Council Assessment Panel Agenda & Reports

16 October 2023

Project
NEW RESIDENCE
For
STEVE & ALISON BROOKMAN
At
23 HARRIS ST, NORWOOD SA

Drawing Title:
SHADOW DIAGRAMS - WINTER SOLSTICE

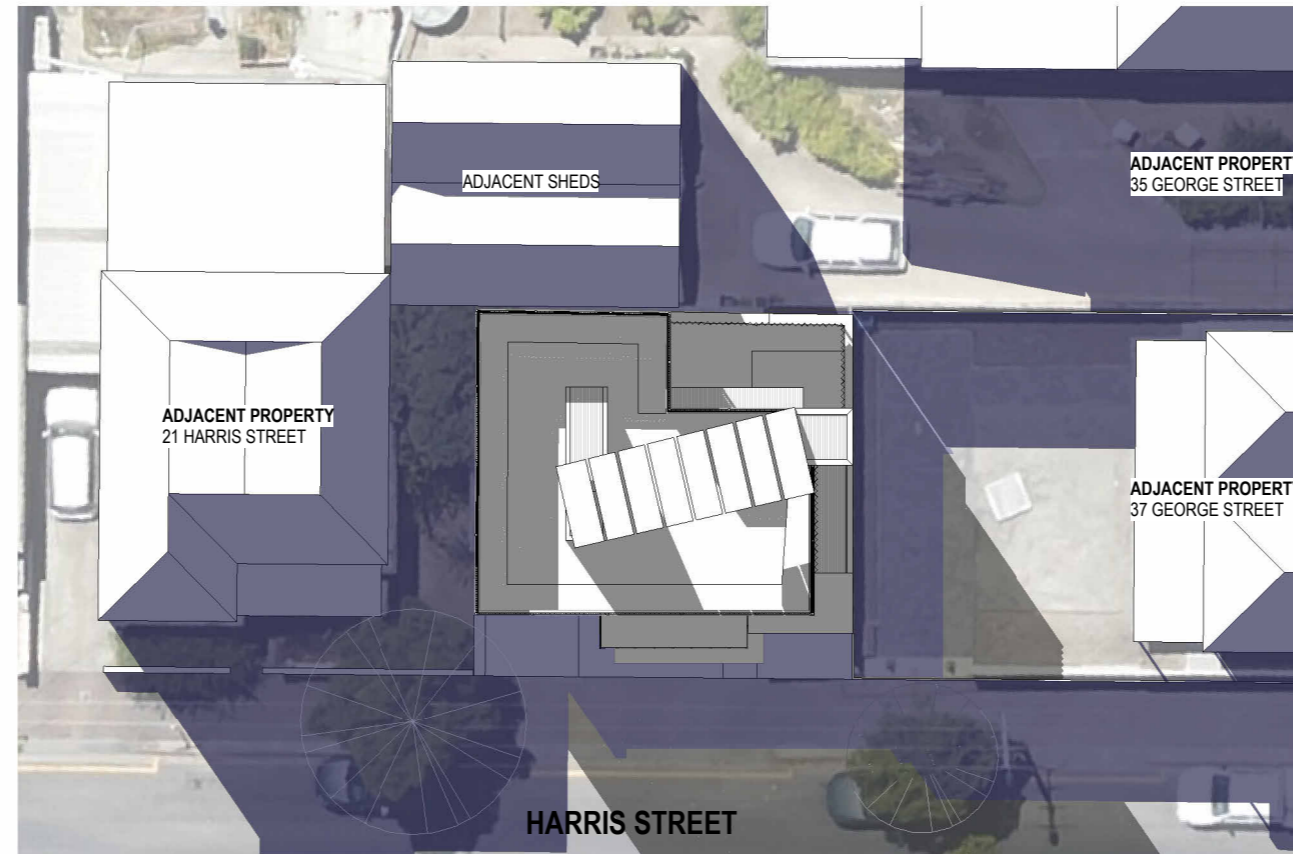
The Applicant has provided shadow diagrams that demonstrate the impact of the development on the private open space of 37 George Street on 21 June. These diagrams show that at 12.00pm the proposed development does not result in any additional overshadowing into the rear yard of 37 George Street. At 3.00pm, the proposed development imposes an additional, approximate 16.6m² of overshadowing into their ground level open space, leaving approximately 32m² of ground level open space not shadowed. Thus, it is reasonable to deduce that between 12.00pm and 3.00pm at least 35m² of existing ground level open space at 37 George Street will maintain 2 hours of direct winter sunlight, satisfying the abovementioned Designated Performance Feature and consequently, in this case, satisfying Performance Outcome 3.2 above.

Drawing Title:
SIGHTLINES SECTIONS

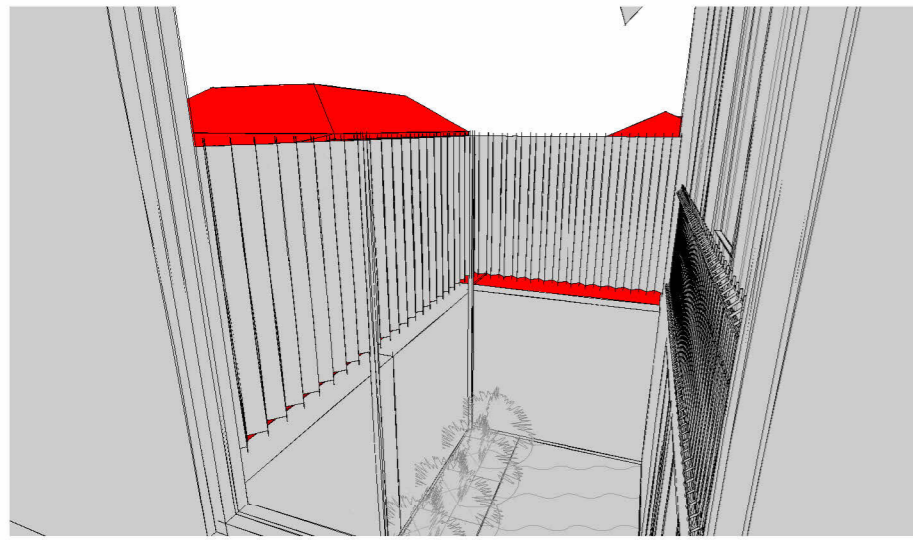
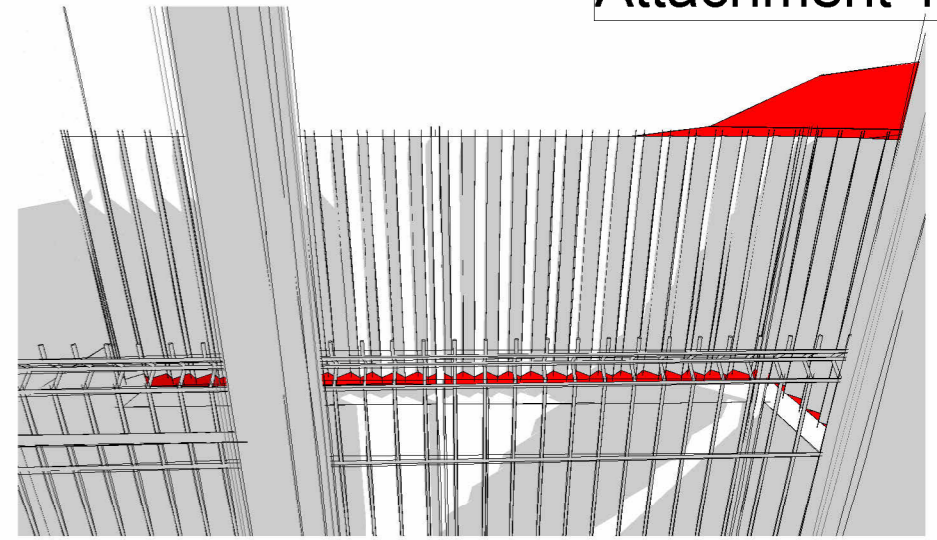
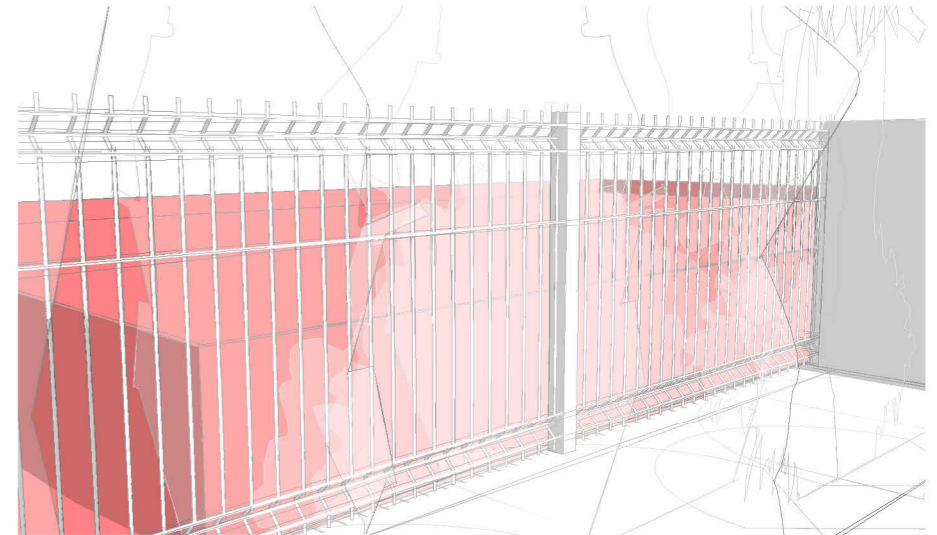
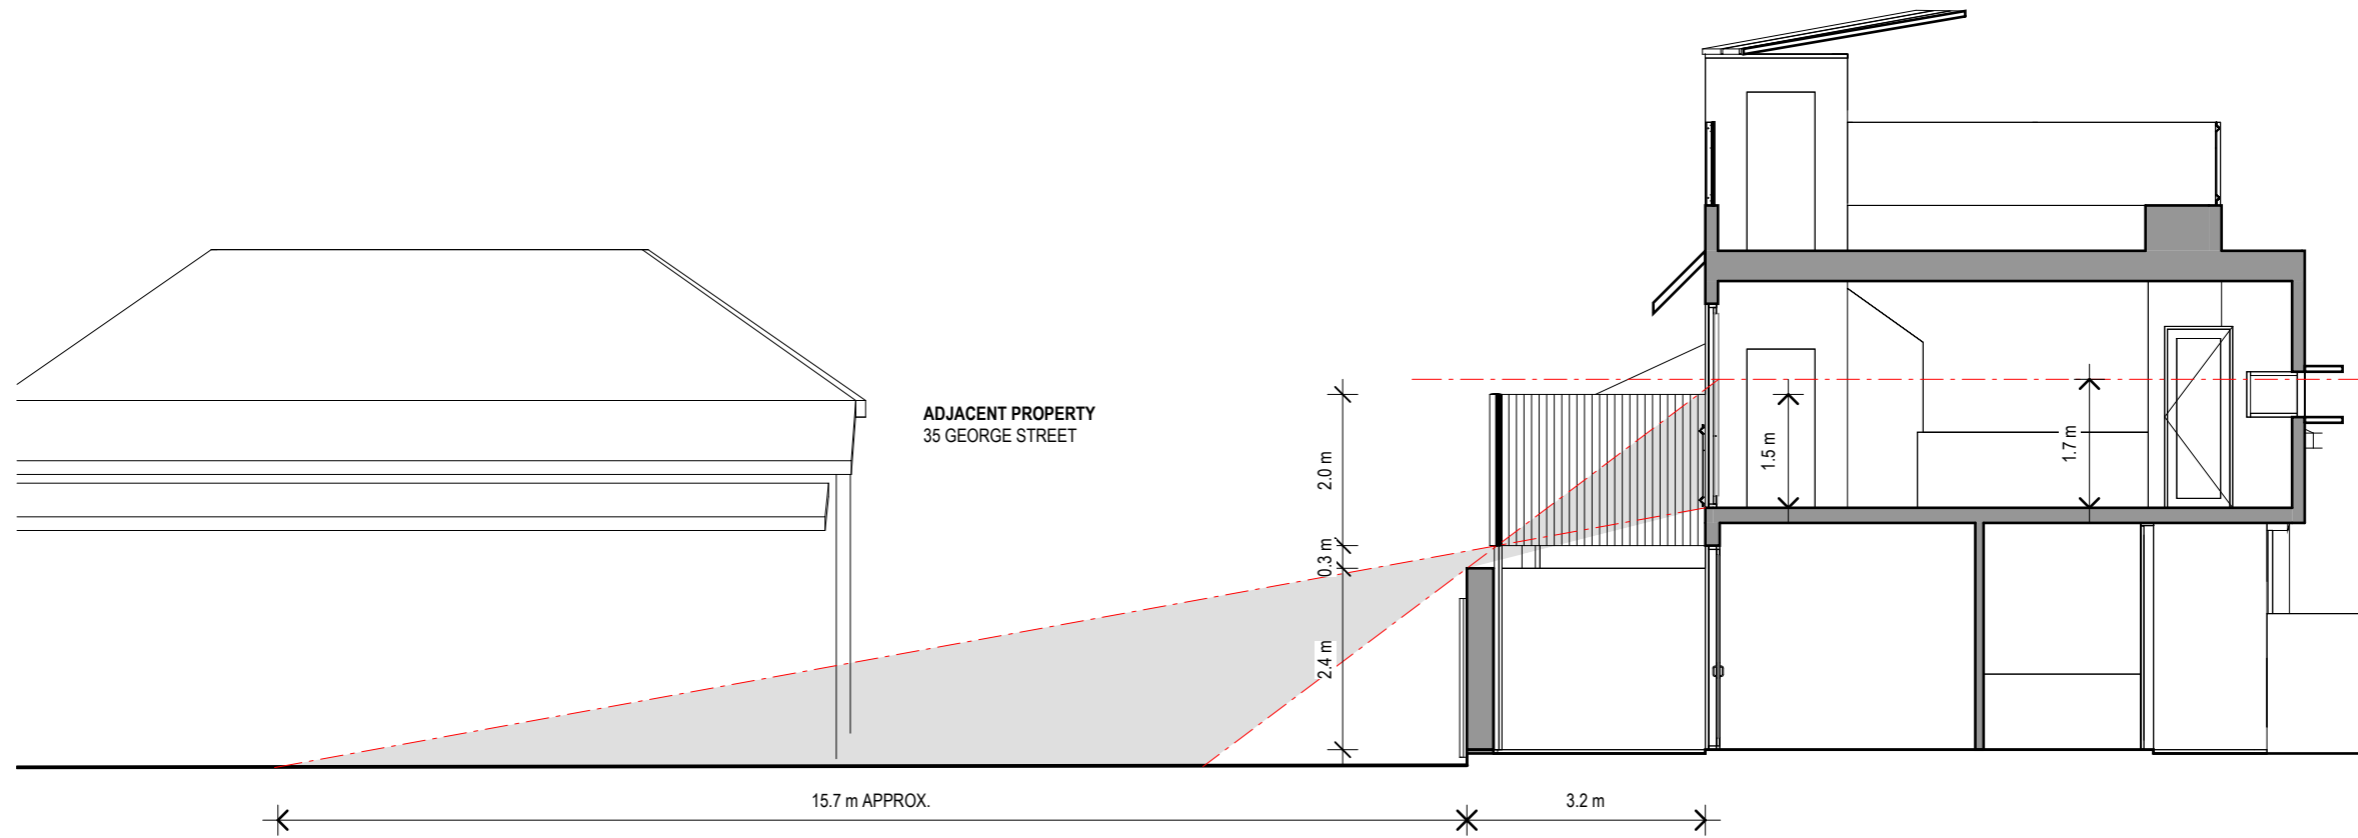
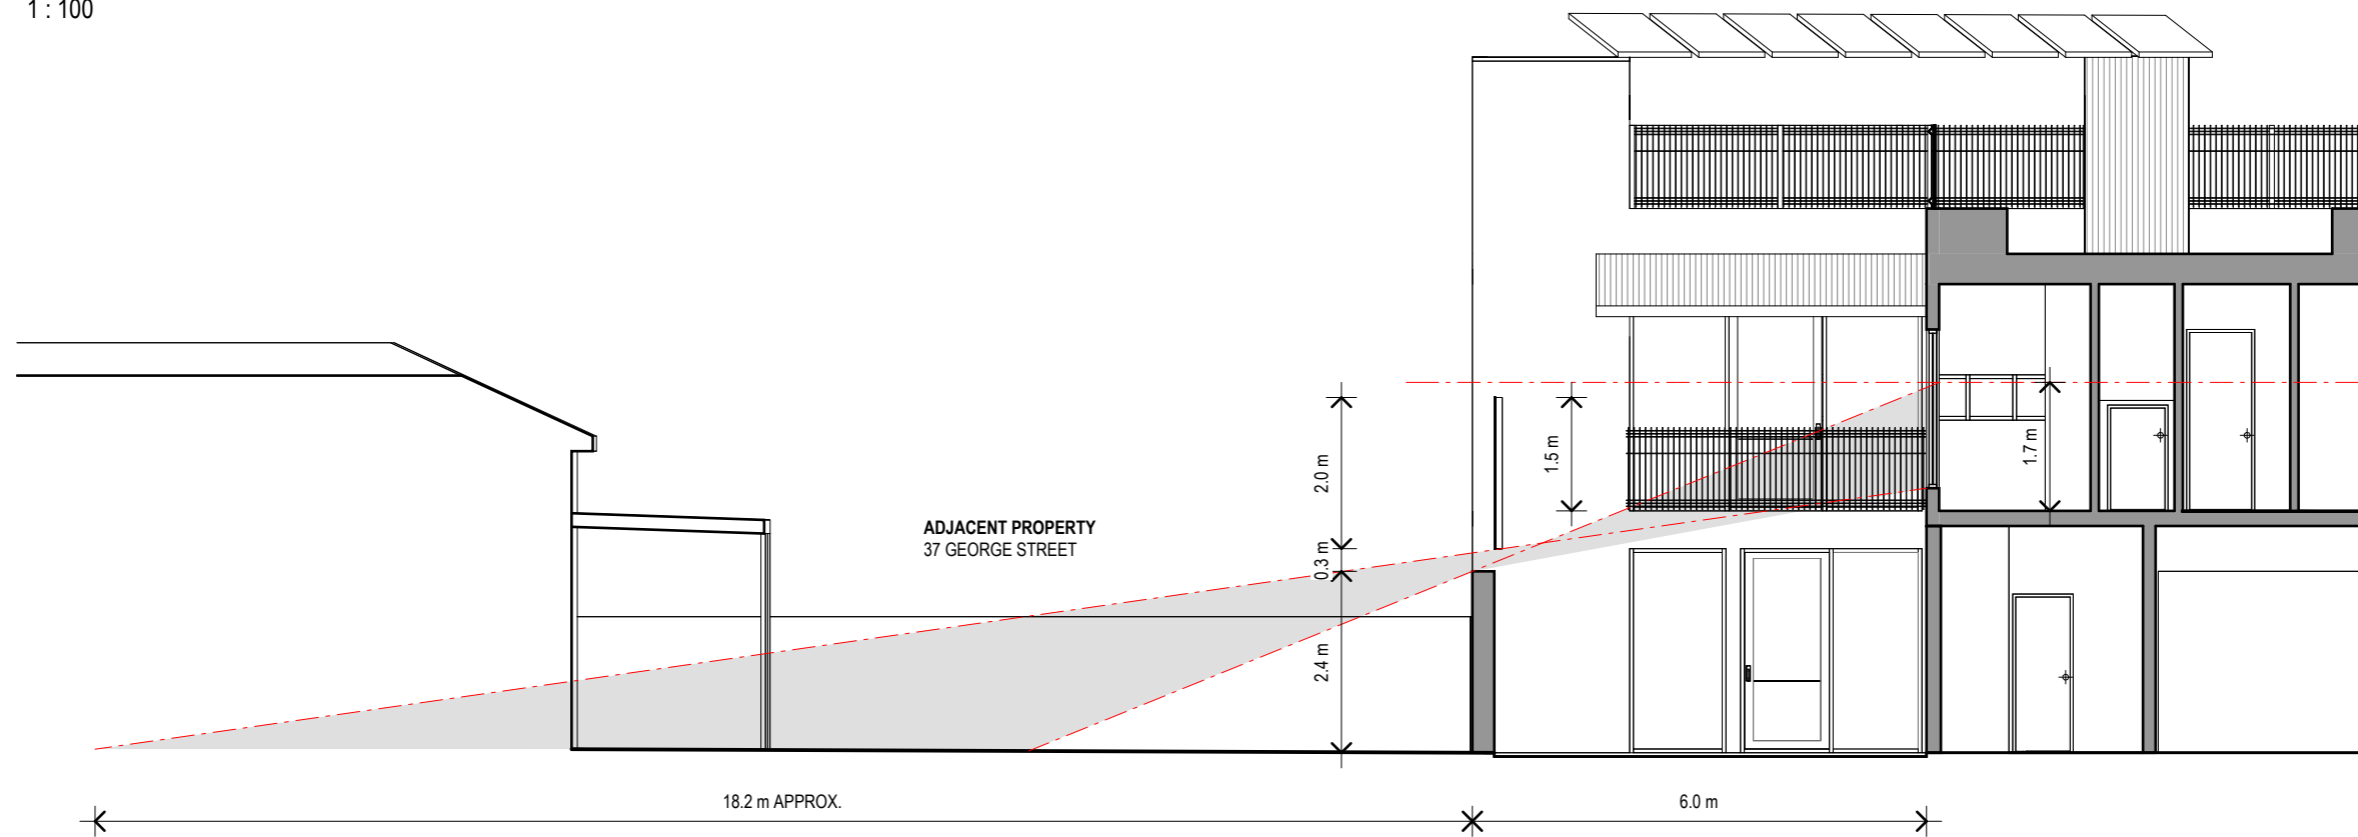
The Applicant has provided 3D sightline images that show the extent of views able to be obtained of neighbouring properties from different points within the second level living space (see **Attachment 1**). These demonstrate that any views into neighbouring properties are very minimal and will not unduly compromise the privacy that the northern and eastern neighbour expect to enjoy. Accordingly, this screen is considered sufficient for satisfying Performance Outcome 10.1 above, and Condition 2 reiterates the requirement to permanently maintain the screen at a maximum 25% transparency.

Original Submission

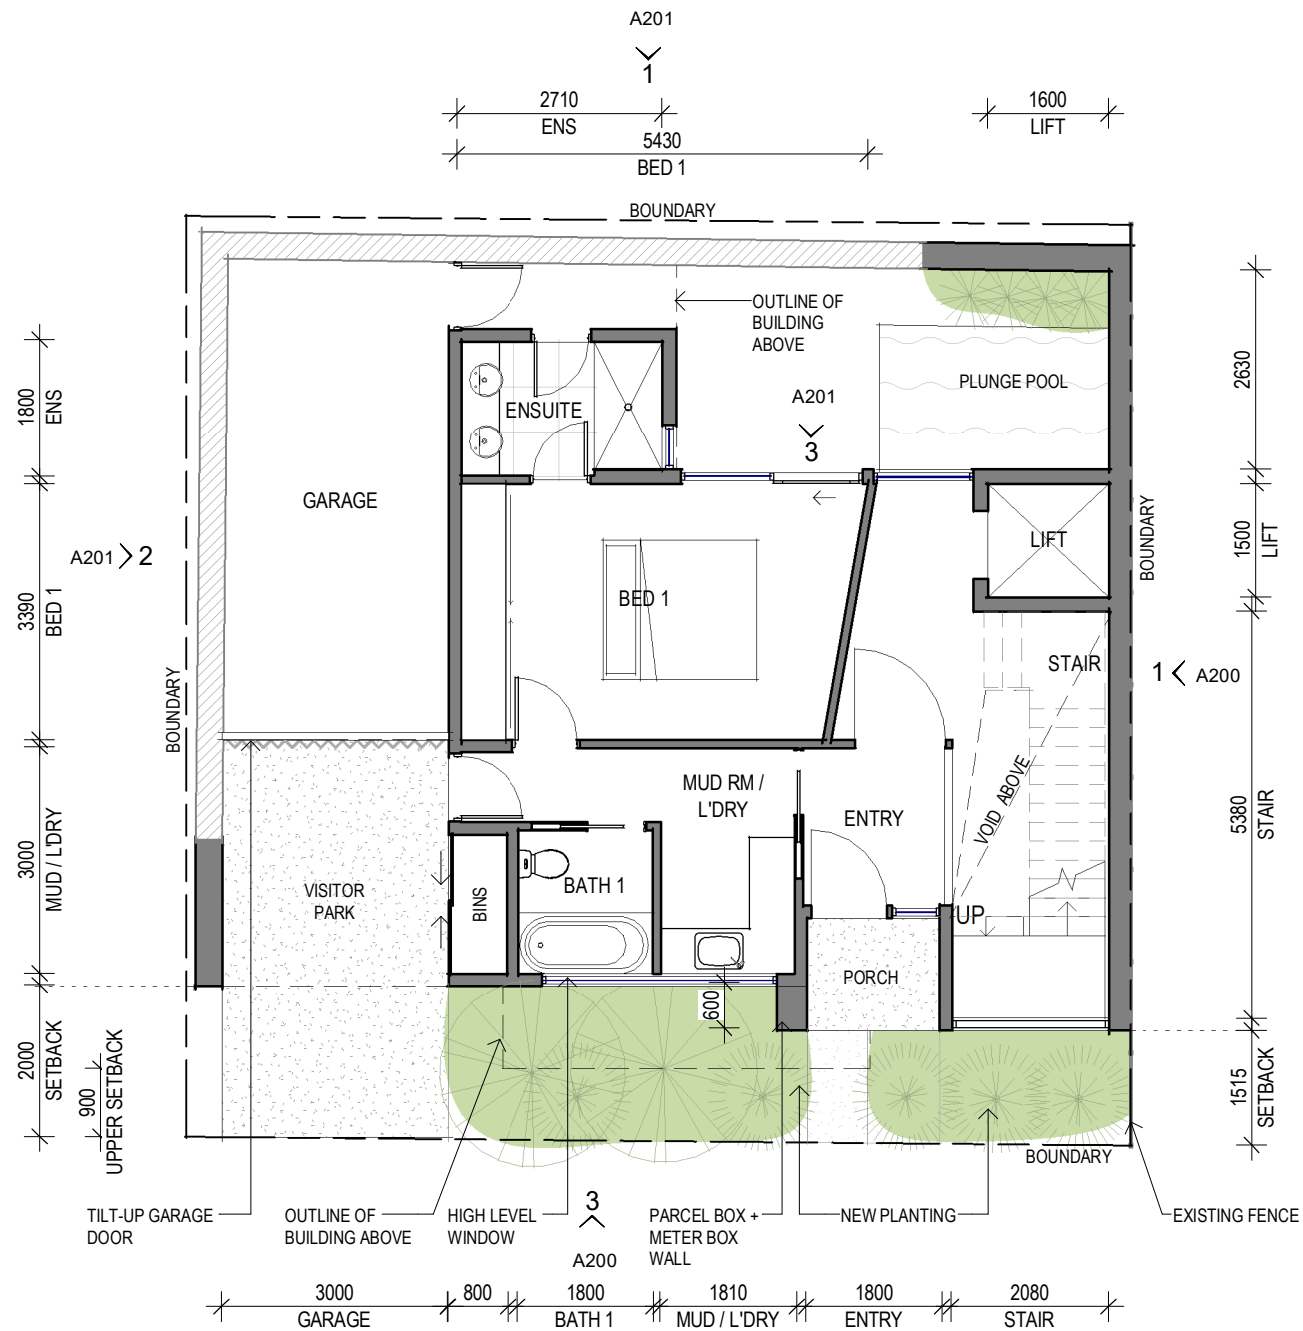
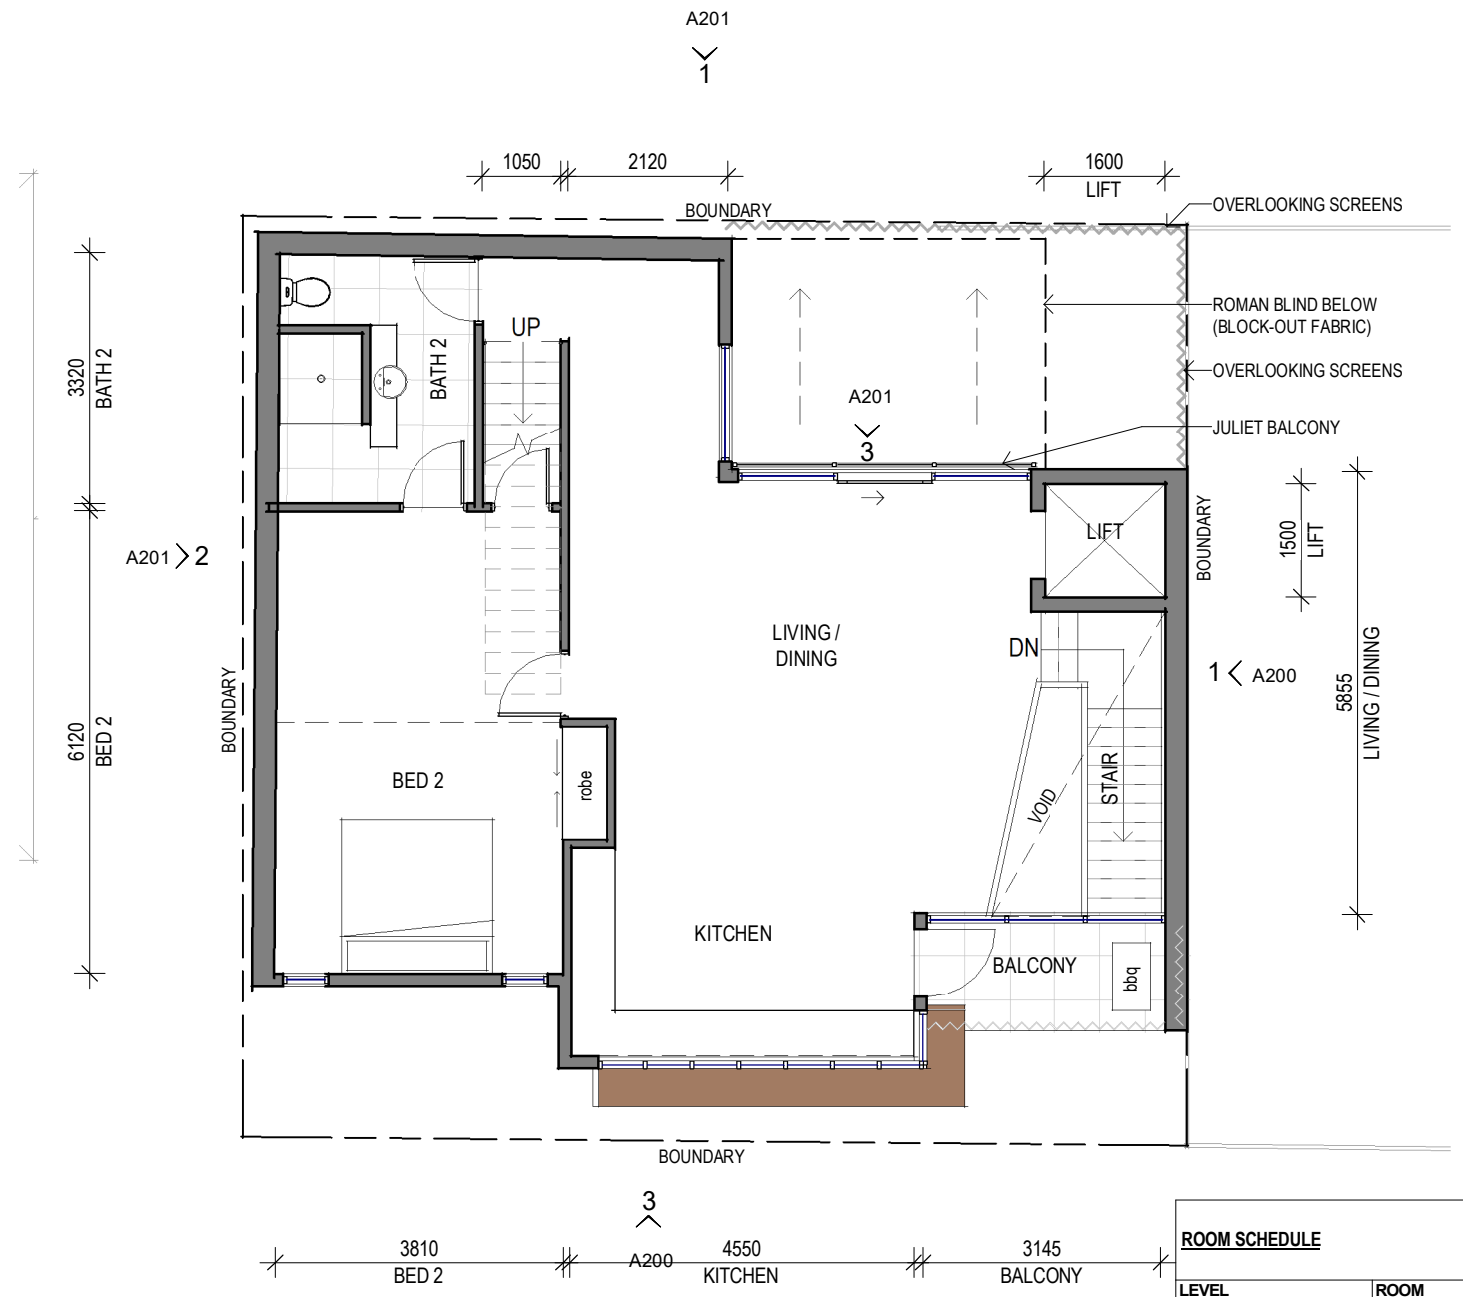
The design of the proposed dwelling introduces the construction of boundary wall abutting common boundary with our client's land measuring 10.69 metres in length representing 87.7 per cent of the length of the boundary. The boundary wall at ground level has a wall height extending to 3.2 metres high, and then extends above that height accommodating the stair well and lift shaft both abutting the common boundary to a height of 9.0 metres. This eastern elevation also incorporates pleated perforated metal screening with a 25 per cent transparency to act as privacy screens at Level 1, which add to visual dominance of boundary structures intruding upon the visual impact of our client's property.

Furthermore, it is considered that the proposed side boundary setbacks do not provide sufficient separation between buildings in a way that complements the established character of the locality and therefore does not satisfy PO 8.1, noting that:
